Cylinder Head Bolt Replacement

HP525 EFI serial numbers M951172 through M953285

HP600 SCi serial numbers M952995 through M953281

Cylinder Head Bolt Replacement and Torque Sequence

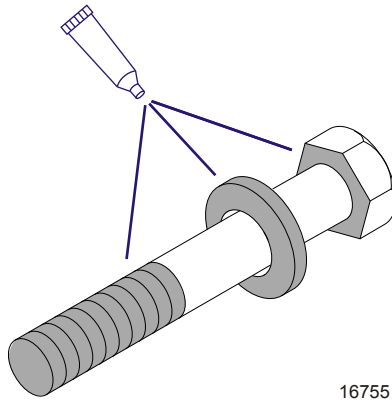
7. Remove both valve covers.
8. Remove the exhaust rockers on cylinders 2, 3, 6, and 7.
9. Replace one head bolt at a time using the following steps:
 - Replace each bolt using the numbered bolt pattern shown in the following torque sequence illustration.

- Torque the bolts to the first torque specification using the following torque specification chart. Do not tighten to final torque until all bolts are replaced.

11. Torque each bolt to the final torque specification using the torque sequence shown in the previous illustration.

Description		Nm	lb. in.	lb. ft.
Cylinder Head Bolts	First	68		50

Description		Nm	lb. in.	lb. ft.
Cylinder Head Bolts	Final (2 times)	95		70
